UPPER TRISHULI-1 HEP (216MW)			
Client	Doosan Heavy Industries & Construction		
DHI's Subcontractor	Power Construction Corporation of China		
REPLY COMMENT			
Subcontractor	Power Construction Corporation of China		
Incoming Document			
Title of the Document	Layout drawing of monitoring for main access tunnel		
Document/Drawing No.	UT1-C-845-CVL-DG-70007	Revision	A
Review Document No.		Reviewed Note No.	RN-0096
Received Date	26032022	Review status	RR
Outgoing Document			
Previous Reply No.		Previous Reply Date.	
Reply No.	RC-000X	Reply date	18.04.2022 2

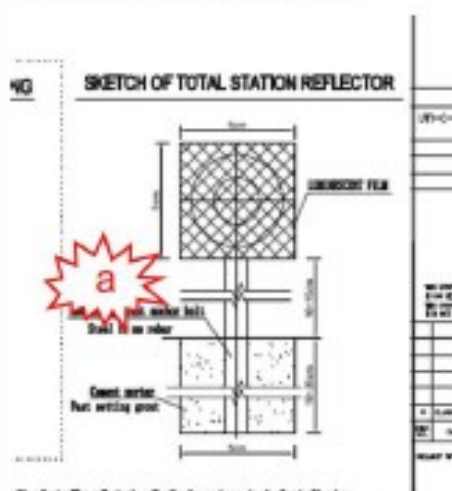
a) Distance between rock surface and target should be "max. 30 mm" and not "10 cm – 15 cm".

- 1) The document was received as pdf-file. To simplify the review by the Engineer and to assist the Contractor in the revision, drawings of the pdf-file were copied into this review note and marked with red letters, and corrections were suggested. Distance between rock surface and target should be "max. 30 mm" and not "10 cm - 15 cm".

Reply ☐ Accepted.
